TYPE II VARIANCE REQUEST

April 1, 2016

RE: Polaris Pointe – Phase I (8886 Lyra Drive)
CC# 17376
PID# 31843101017000

**EXHIBIT A - FULLY COMPLIANT
CC 17376**

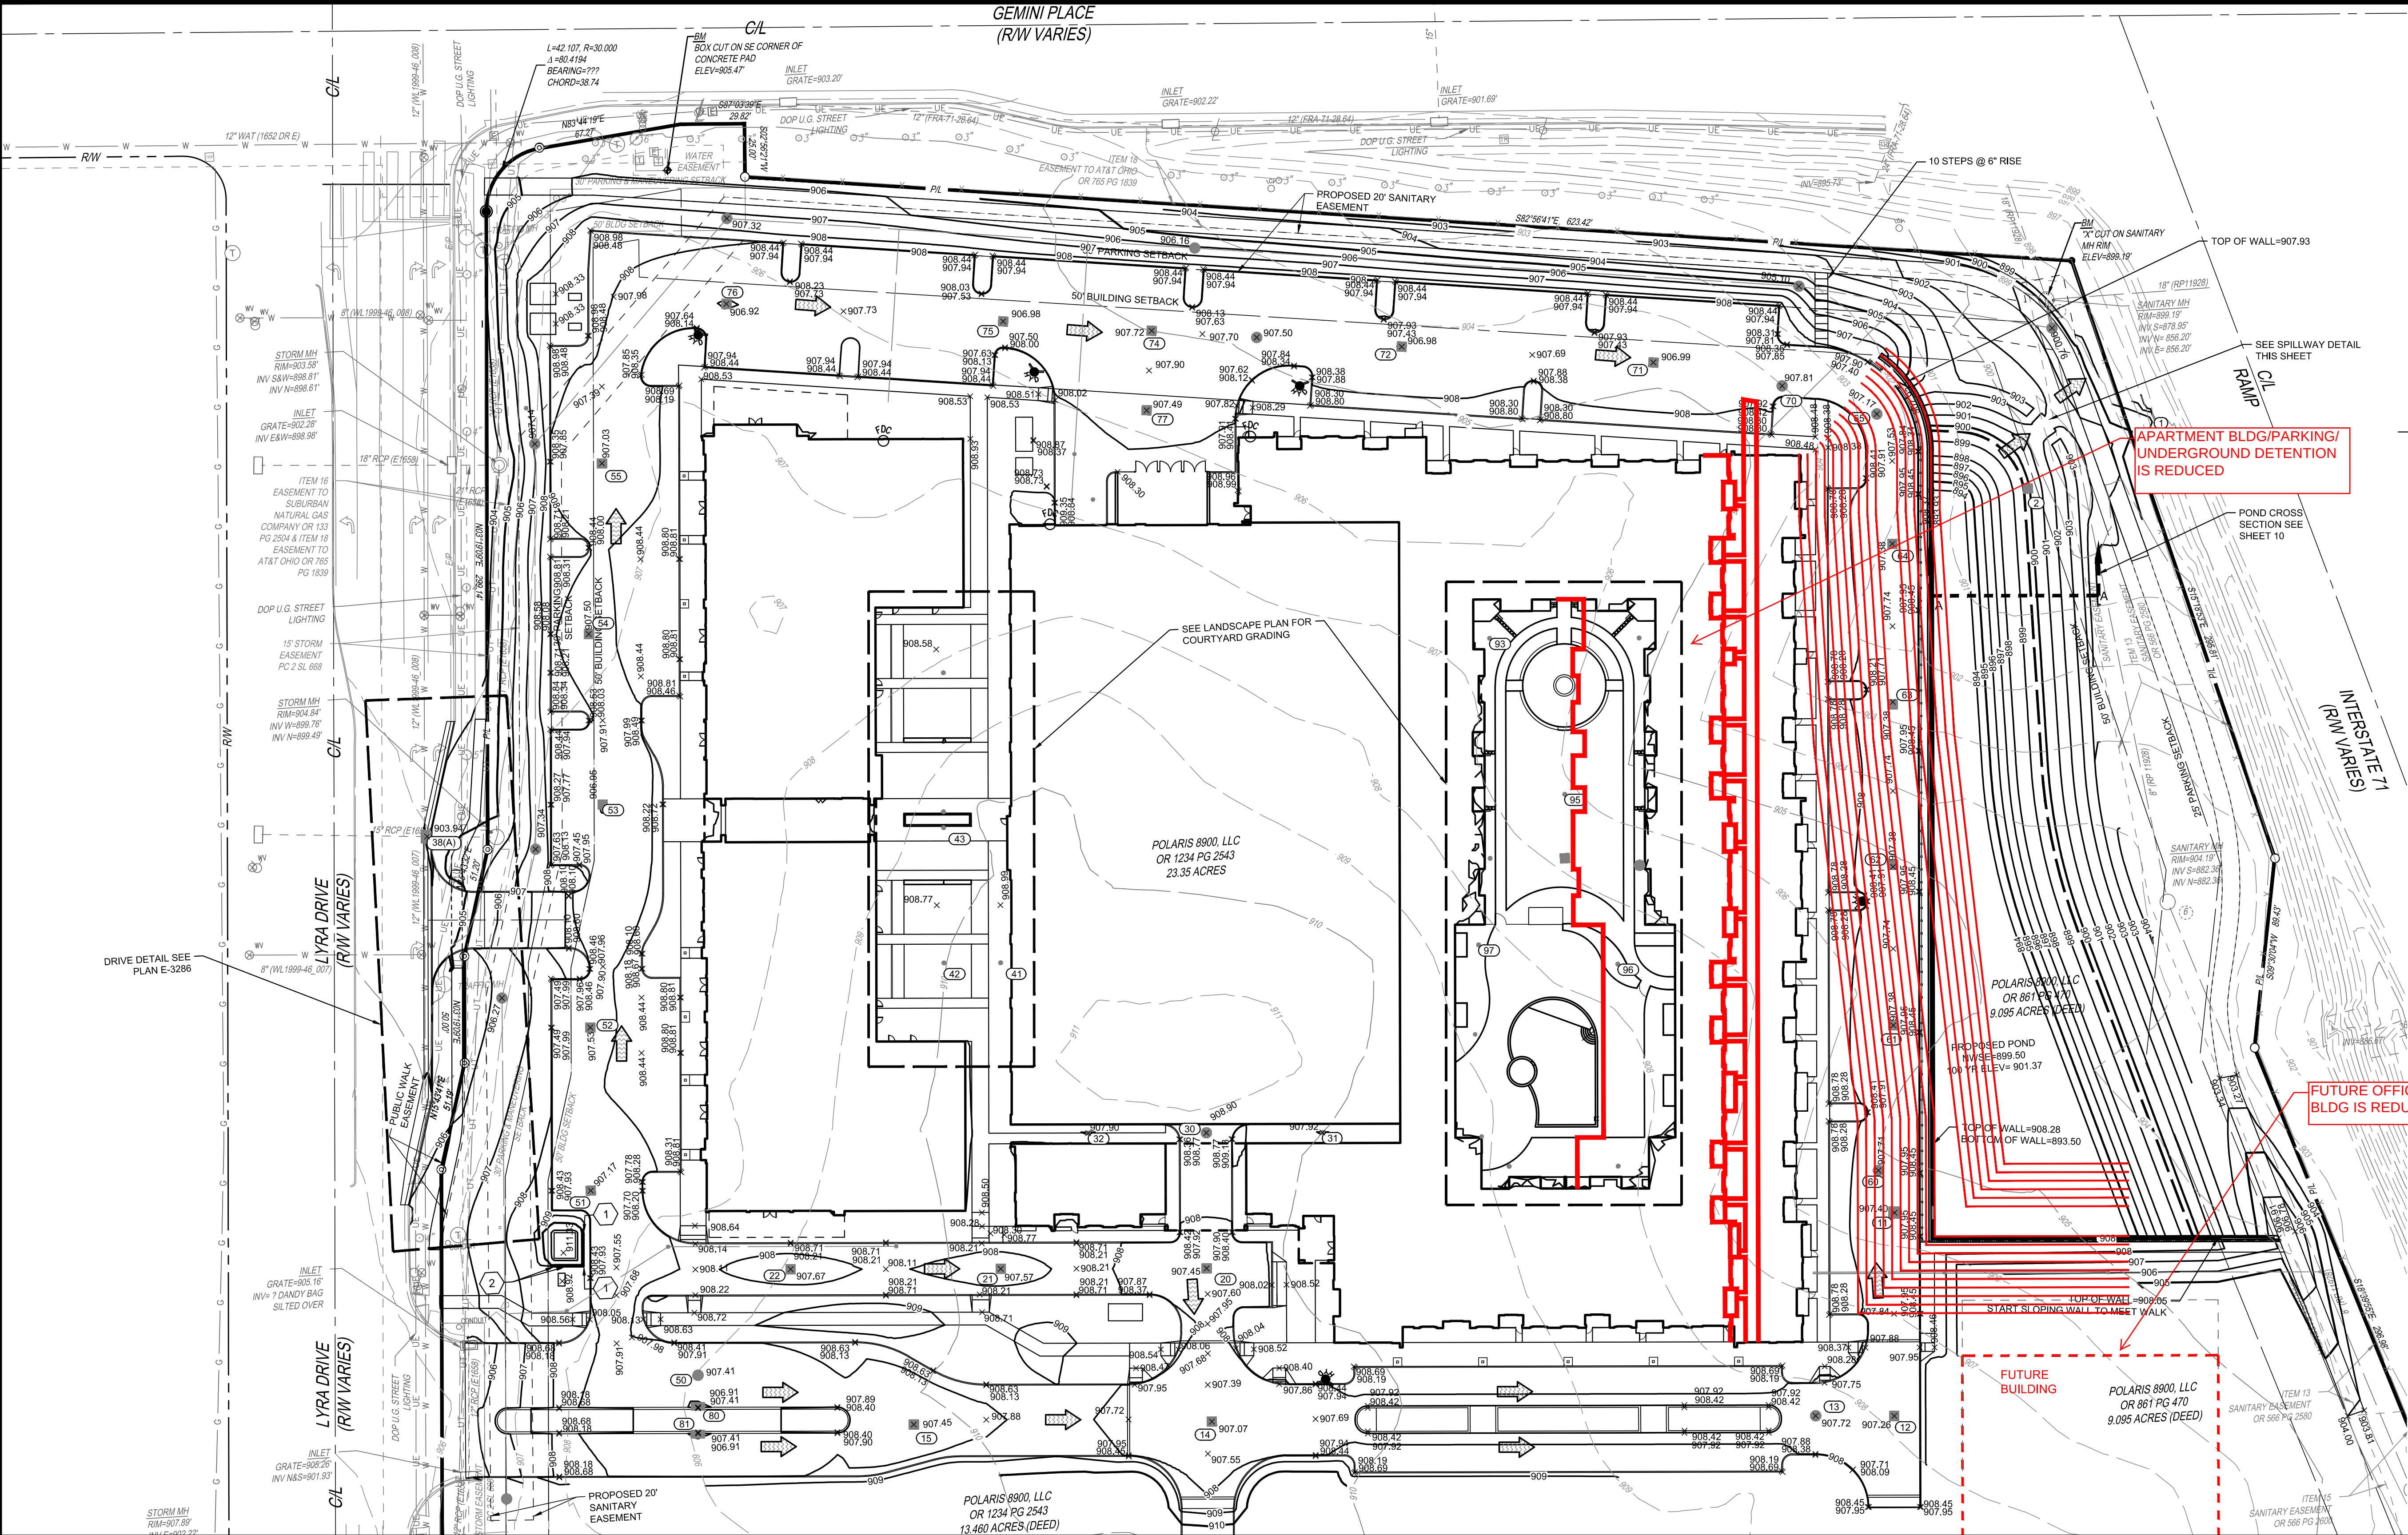
Fully Compliant Alternative (See Exhibit A)

A fully compliant alternative would remove both of the proposed retaining walls and enlarge the basin to the west and south such that the side slopes and aquatic bench are incorporated. Both requirements place an unnecessary hardship on this project. The additional area for the slopes would cut into the site by over 65'. A 20' lane would be left on the east side of the apartment building for fire access and circulation only. This equates to a loss of the following development:

Apartment Building – Loss of 18,816 SF of building + 52 parking spaces + the courtyard space becomes unusable and eliminates the pool

Future Office Building – Loss of 12,488 SF of building

Given the loss of 52 parking spaces, based upon the parking reductions previously negotiated, this equates to a loss of close to 40 units in the apartment building. This reduction would make this project economically infeasible to move forward.

EXHIBIT B - PREFERRED

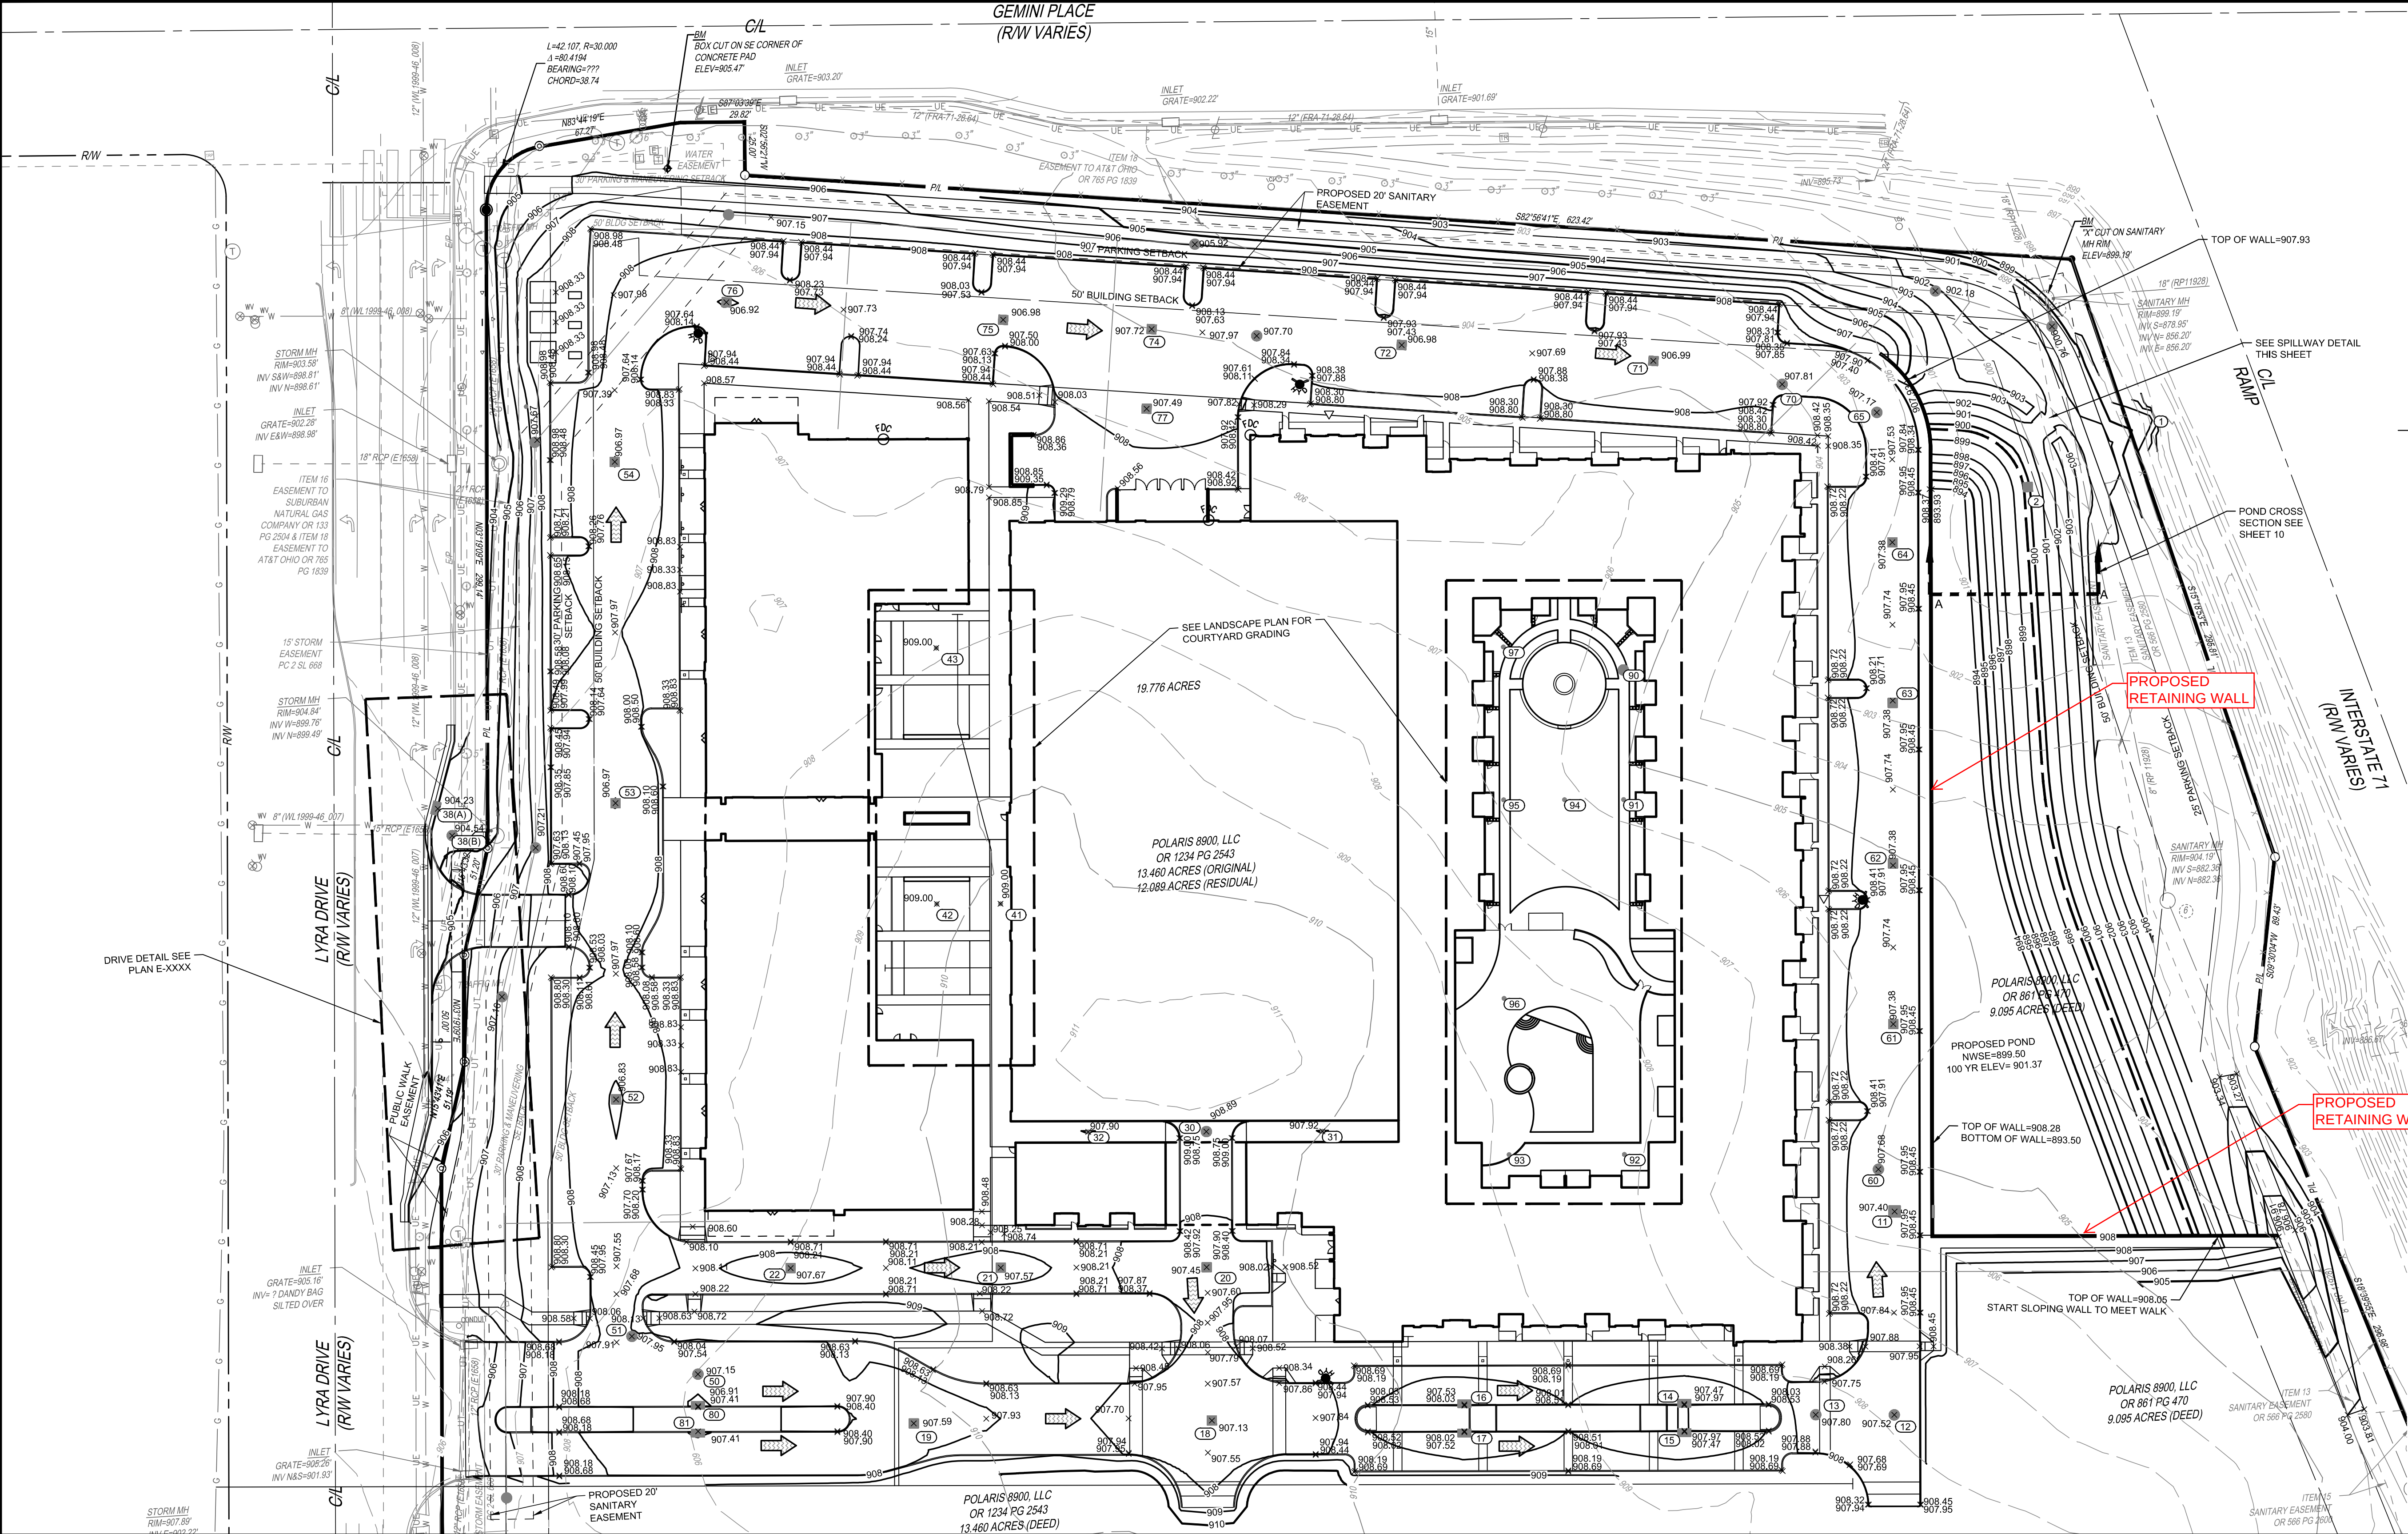
Preferred Alternative (See Exhibit B)

This project is proposing a retaining wall on two sides (west and south) of the wet basin in order to maximize the available space to meet required storm water quality and quantity volumes in conjunction with underground detention upstream of the basin while still providing enough developable ground to make the project financially feasible. Due to the proposed wall along these two sides, the 4:1 side slopes are not met and a safety bench is not proposed because it would not be accessible or maintainable. However, the sloped sides of the basin where there is no wall do meet the 4:1 side slope and aquatic bench requirements. The retaining wall is being proposed

on two sides in order to attain the maximum development to meet return on investments at this particular parcel in the Polaris Centers of Commerce.

The developer is working closely with other departments at the City on T.I.F. agreements for public infrastructure to also make this project viable. The basin as proposed still will not fully meet the water quality and quantity volumes required. For this reason, the project is also proposing upstream, underground detention in the parking areas of the project. Since there is a proposed walk adjacent to the retaining wall on the south side of the basin, a 42" tall pedestrian guardrail is proposed on top for safety measures. The retaining wall on the west side of the basin includes curb, vehicular guardrail and landscaped area with trees and a continuous hedge for safety measures (See Exhibit C for a detail of the south and west cross sections). Note that the west side of the basin does not include sidewalk or pedestrian pathways along this edge so a taller guardrail has not been proposed on this side. In addition, previous projects in this area such as CC-16295 and CC-16925 have been approved with similar walls along ponds that also do not meet the slope or aquatic bench requirement due to the walls proposed.
